Re: Response to El Paso County Review Comments
Monument Ridge East
Monument Hill Road and Palmer Divide Road
El Paso, Colorado
Entech Job No. 230248

Ref: Entech Engineering, Inc., revised date July 16, 2026. *Soils and Geology Study, Monument Ridge East, Monument Hill Road and Palmer Divide Road, El Paso County, Colorado.*
Entech Job No. 230248.

V5_Soils & Geology Report.pdf Markup Summary

FIG. 1

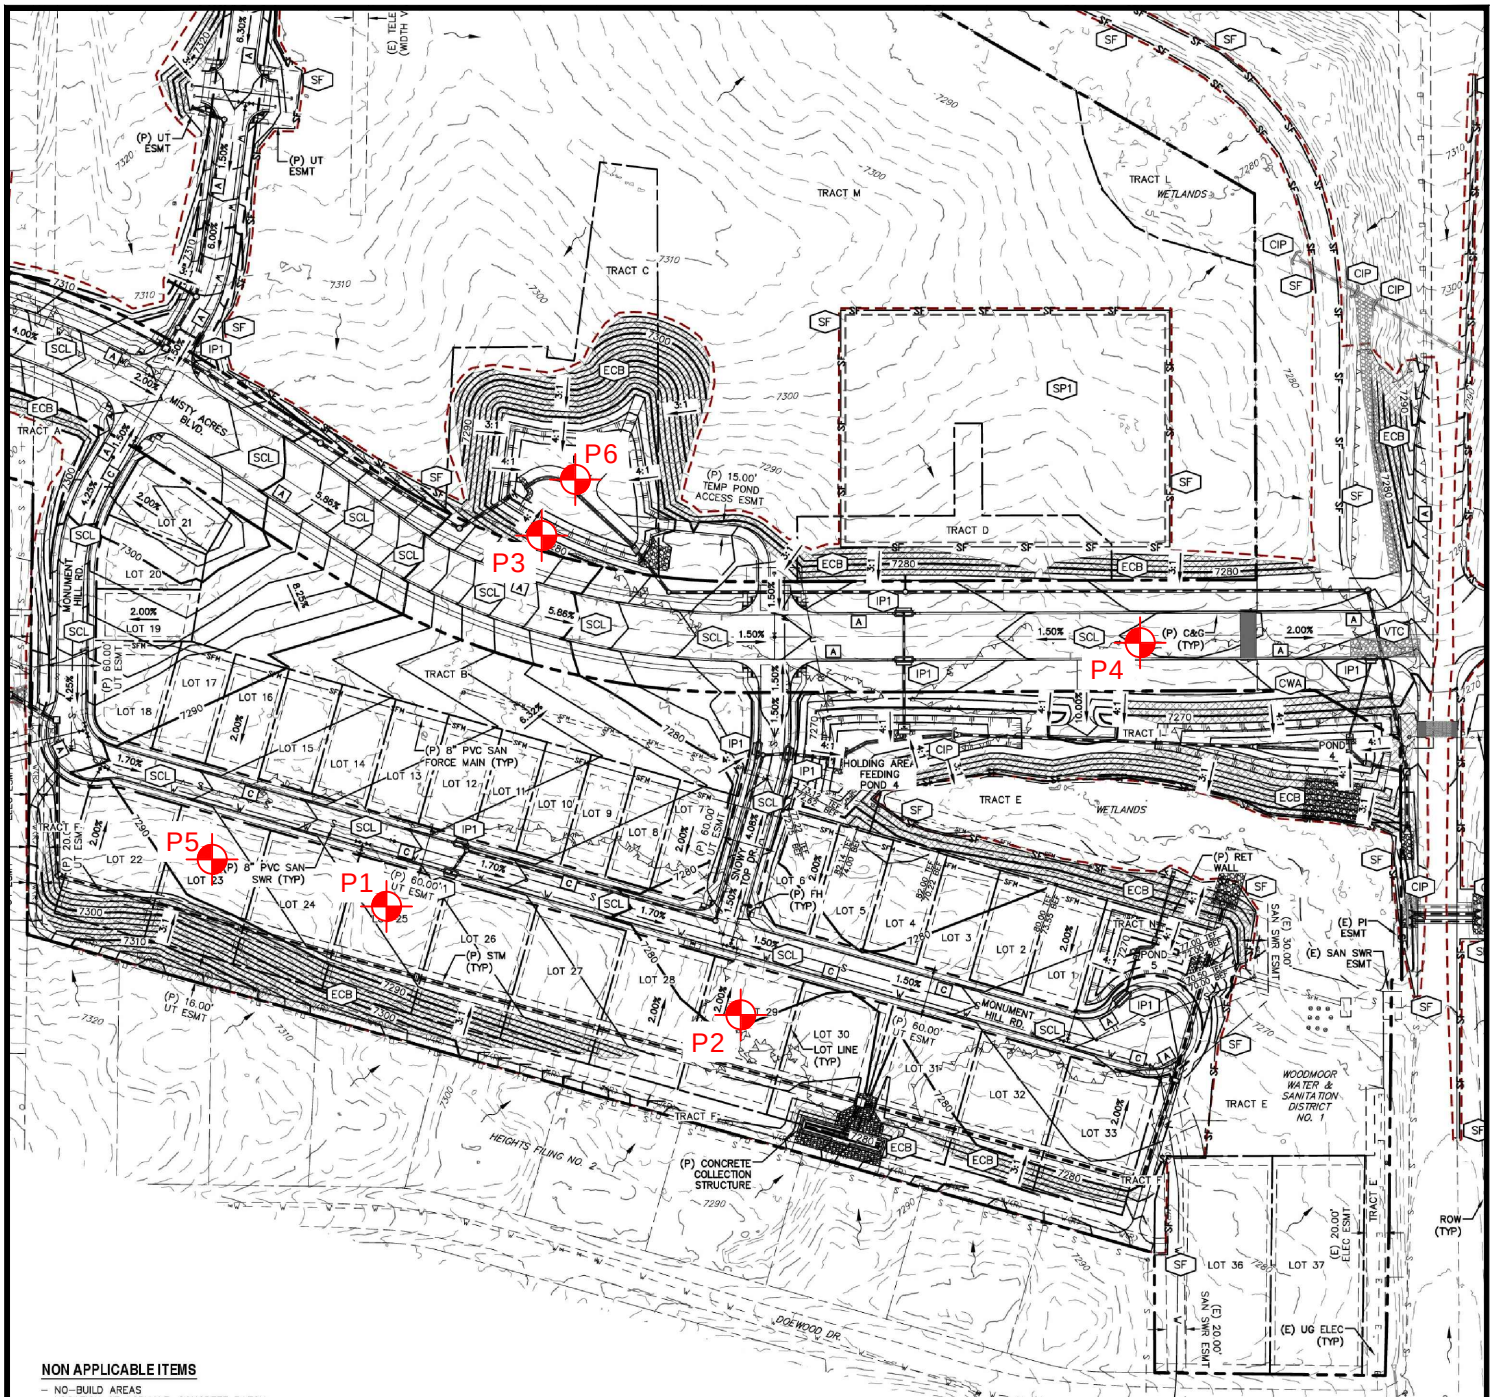
When will groundwater be determined for construction? Will testing be done prior to construction, early grading, or during construction? If groundwater is encountered within 5 vertical feet of public ROW or drainage facilities, additional reports and testing will be required to address shallow groundwater. (See ECM C.6.1)

- It is our understanding that underdrains will be installed on the site. In areas where water is in close proximity to foundation grade additional drains will be required. Drain details for underslab and interceptor drains have been included in the Soils and Geology Study.
- Entech will continue to monitor the temporary piezometers throughout the coming seasons and during the development process. Additional site subsurface investigations will be performed as development is completed. Additional piezometers will be completed as needed.

Entech installed two additional piezometers on July 21, 2026 (P5 and P6). P5 was placed on proposed Lot 23, and P6 was placed in the bottom of Pond 2. The locations of the piezometers for the site are shown in the Piezometer Map, Figure 1. The test boring logs for the two additional piezometers are included in Appendix A, and Laboratory Testing Results are included in Appendix B. Piezometer readings for the development are included in Exhibit 1.
